**ADDENDUM #01
TO THE BID & SPECIFICATIONS FOR
BOLTON ESTATES WASTE WATER REHABILITATION
COUNTY PROJECT SBI 000367
February 22, 2016**

This Addendum forms a part of the Contract Documents and modifies the original specifications and drawings. This Addendum consists of one (1) page plus the five (5) attachments listed here:

FISHER ARNOLD ENGINEERING INTEGRATION 9180 Crestwyn Hills Drive Memphis, Tennessee 38125-8538 901.748.1811 Fax: 901.748.3115 www.fisherarnold.com	BOLTON ESTATES WASTE WATER SHELBY COUNTY BOLTON, TN		DESIGN: JWO DATE: 01/14/2016 JOB #: A9105	DRAWN: JWB RECIRCULATION TANK	SCALE: N.T.S.	SHEET C104

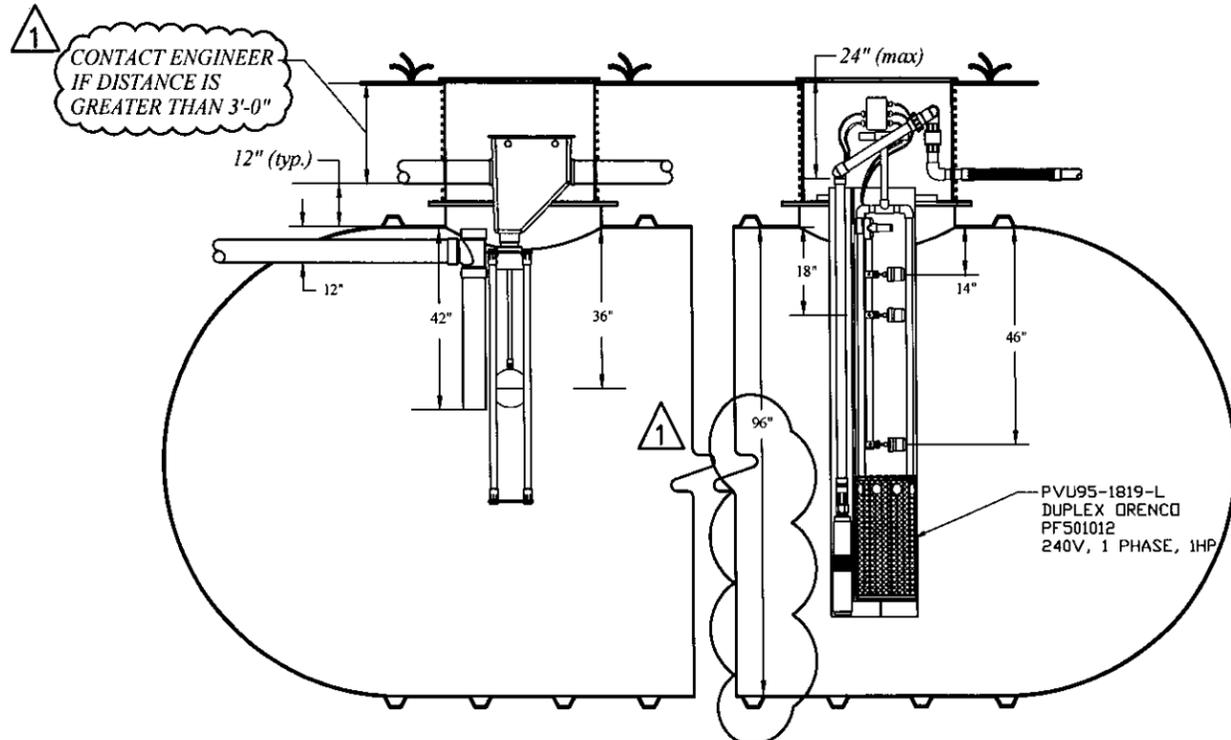
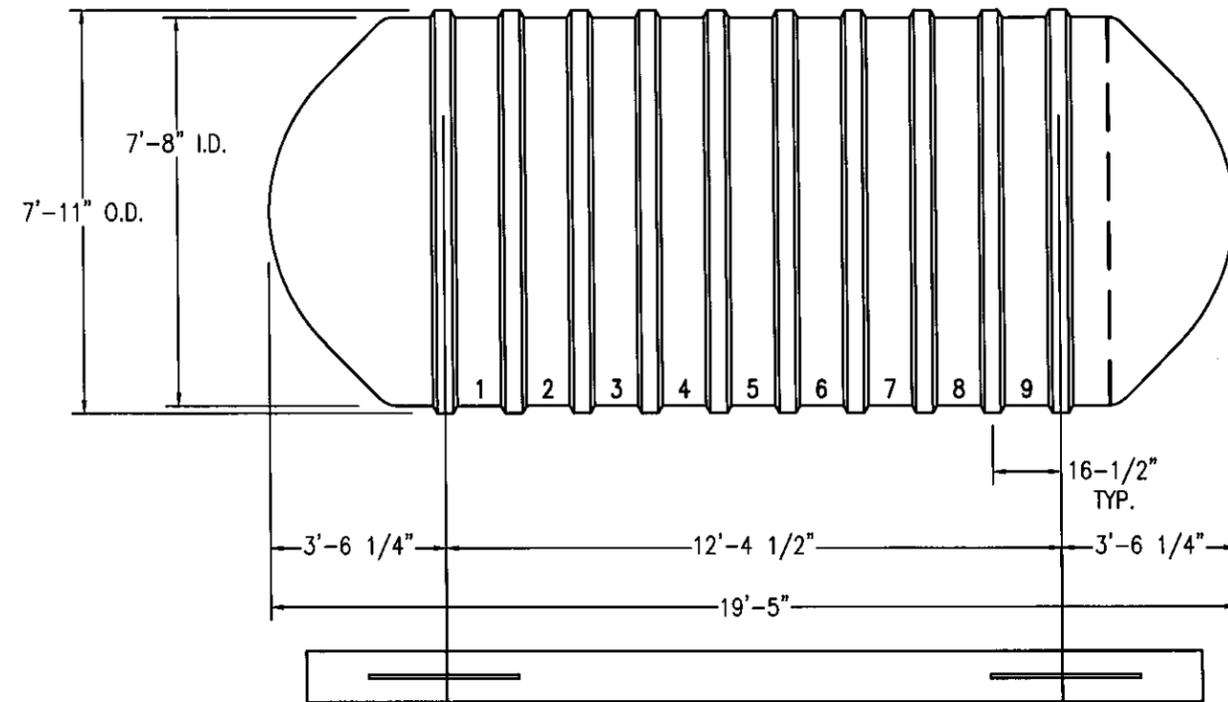
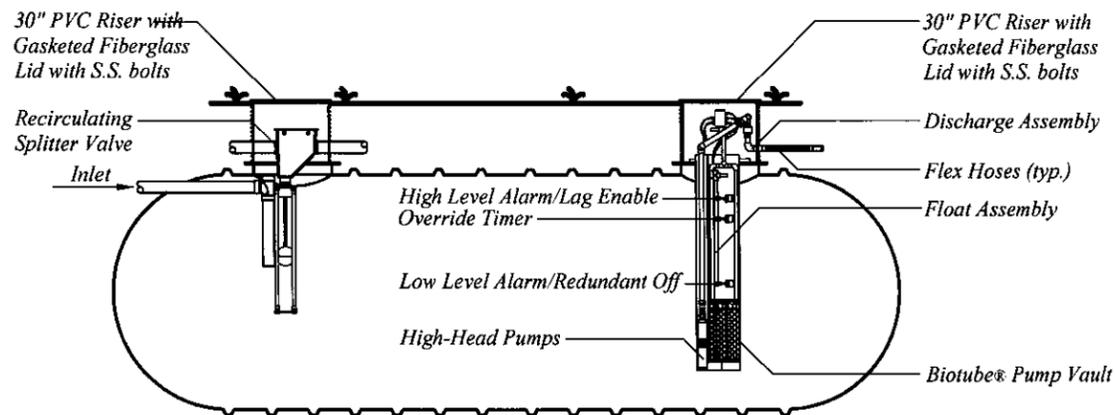
Attachment 4: SHEET C104 RECIRCULATION TANK

- Relocated 96" dimension line to bottom of tank.
- Added maximum depth note for the discharge gravity line.

POD DETAIL- MOUND OPTION

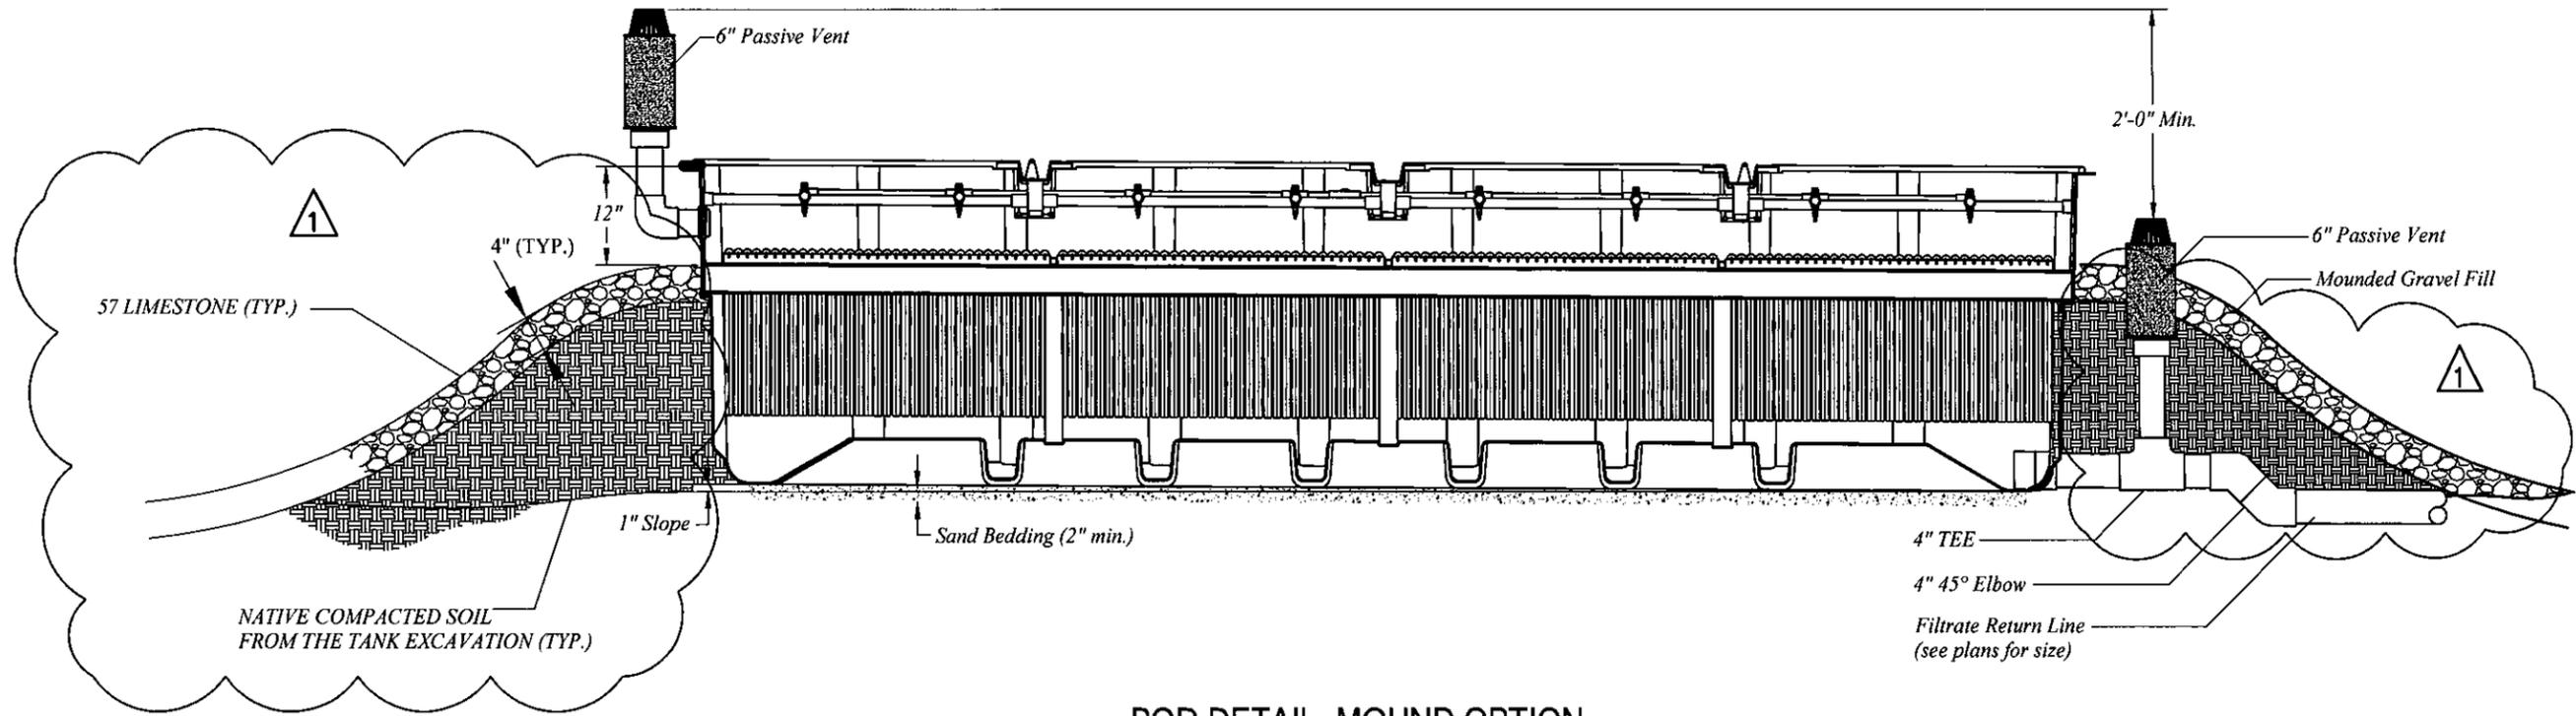
Attachment 3: SHEET C103 PASSIVE VENT DETAILS

- Mound option should include dirt and 4 inches of no. 57 stone on top.
